SUPPLEMENT
28 November 1951

SUPPLEMENT TO
TM 11-2234
TELETYPEWRITER TT-4/TG

The following information, published on Order No. 1671-Phila-51, supplements TM 11-2234, April 1951. The serial numbers of the equipment covered in this supplement are:

Figure 185. Teletypewriter TT-4A/TC, interconnection diagram.

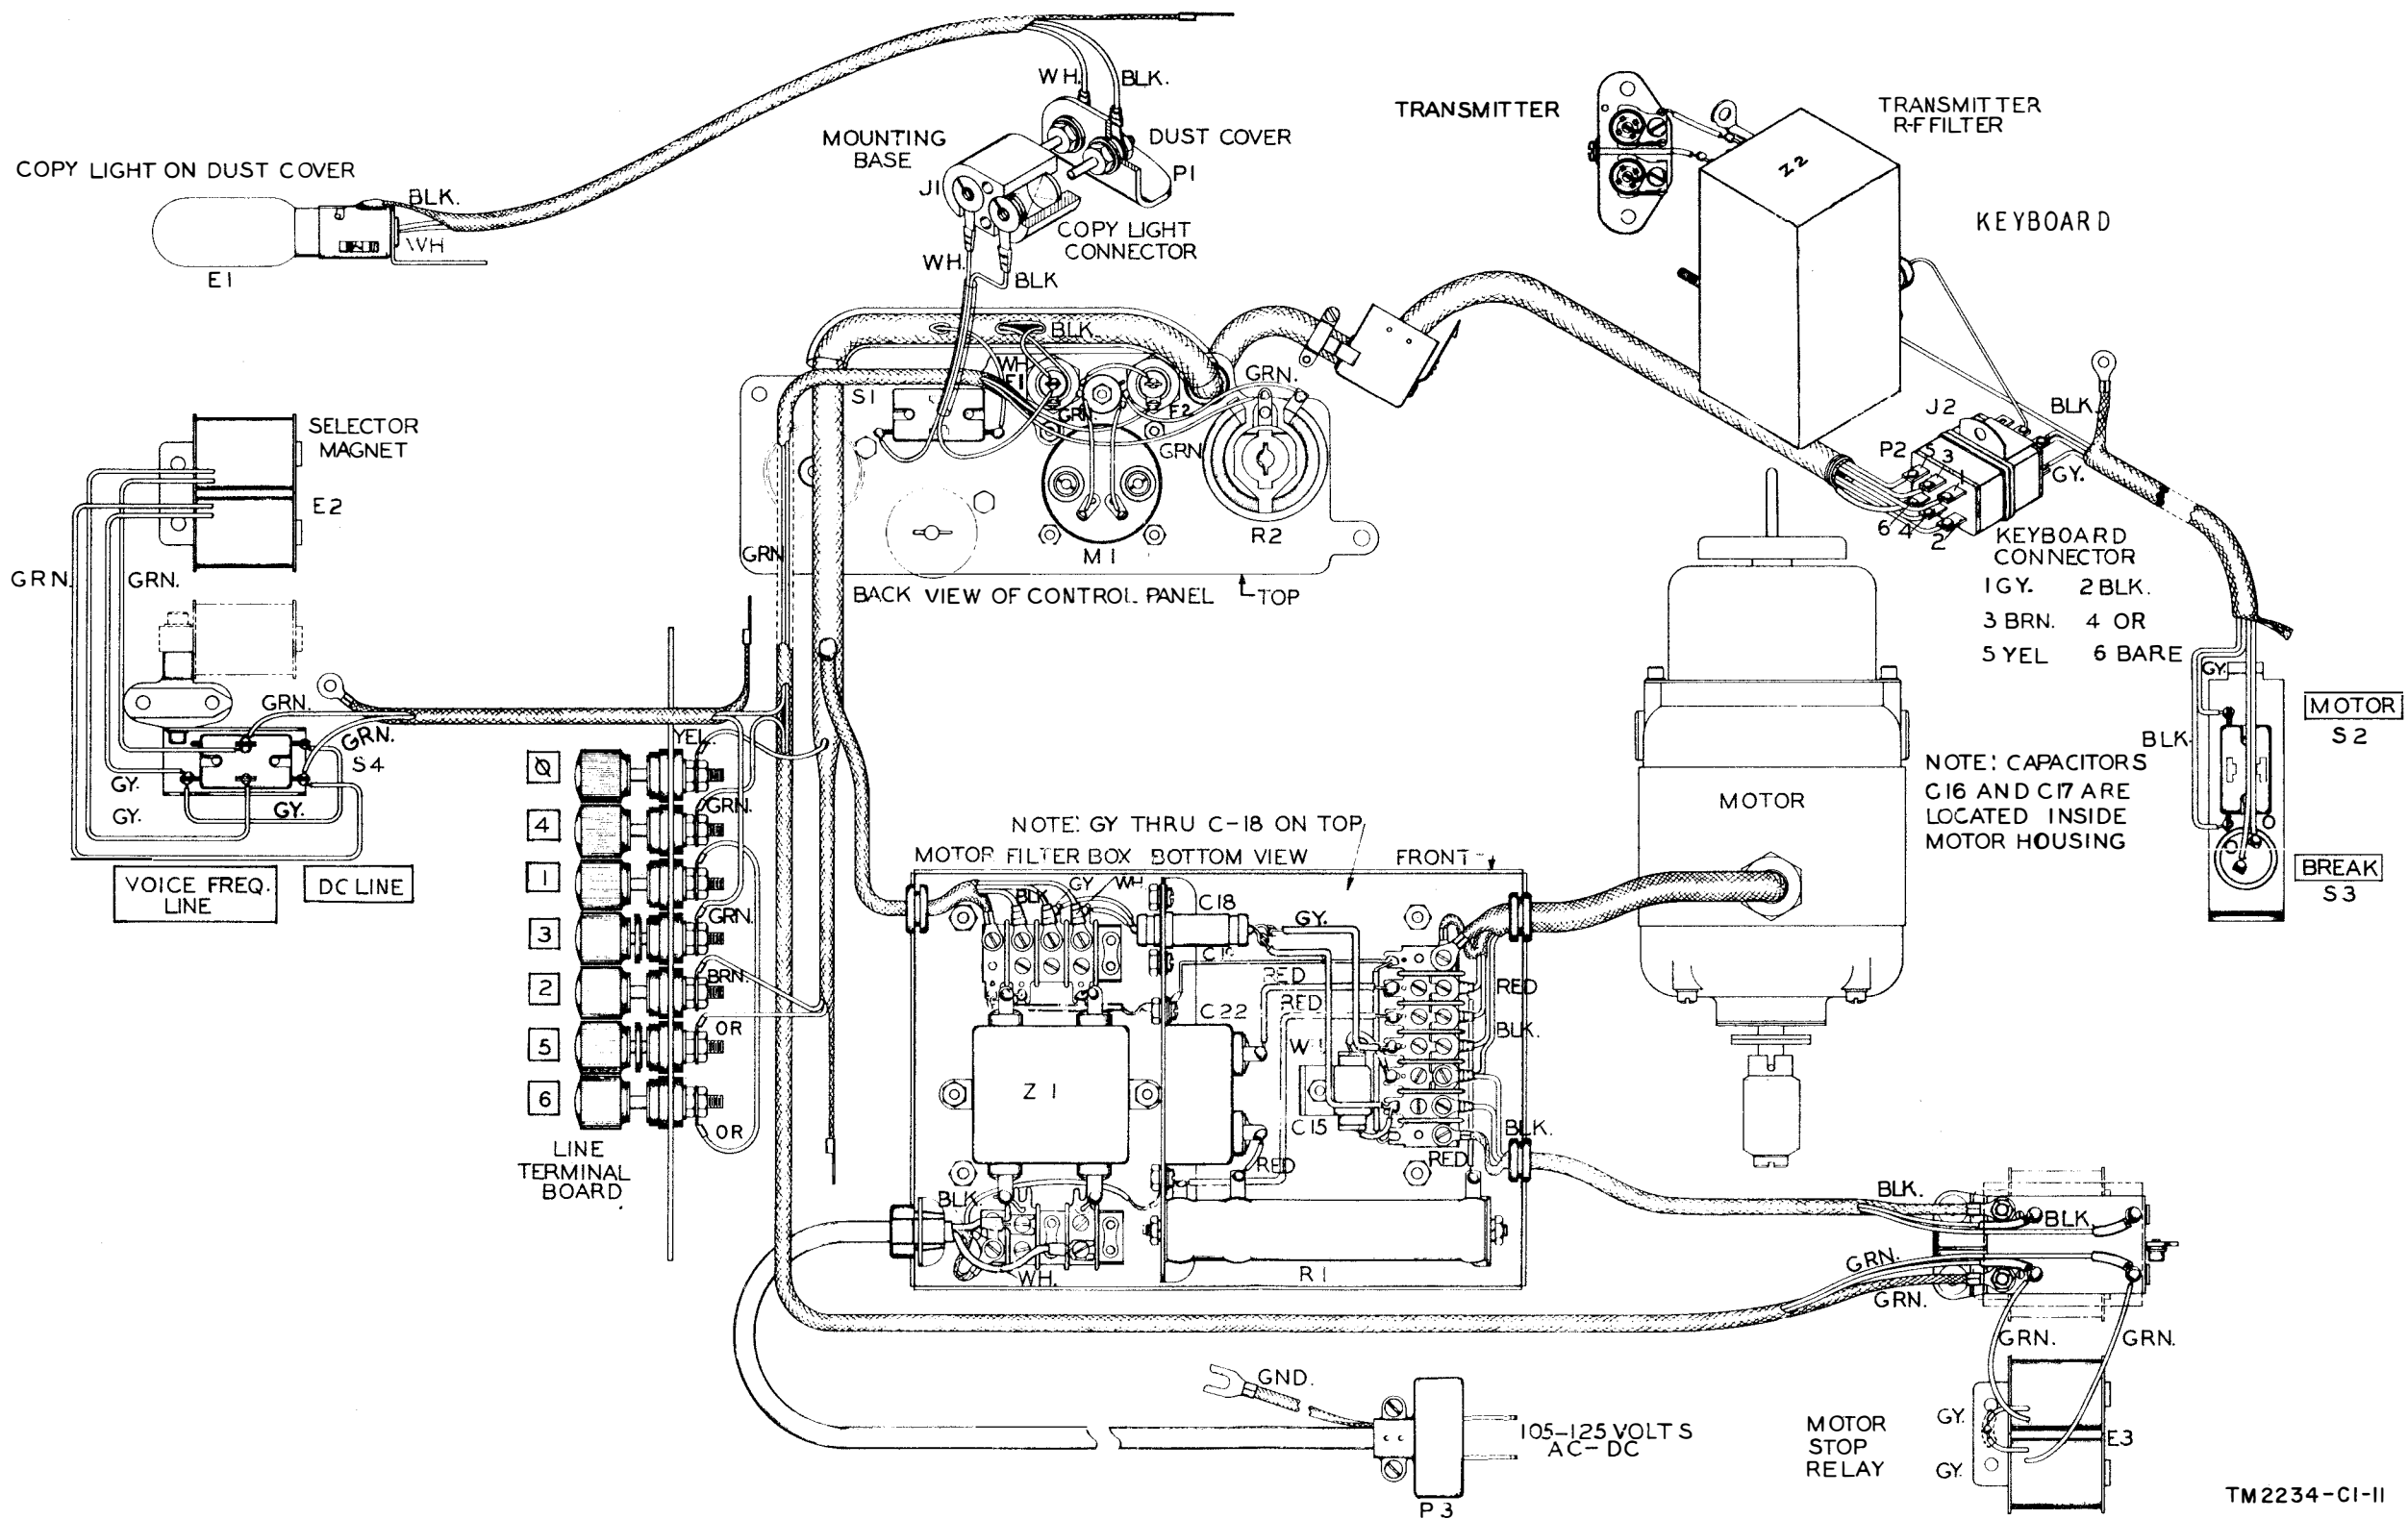
Page 190. Fig. 185. Delete figure 185 and substitute the following: (See end of supplement.)
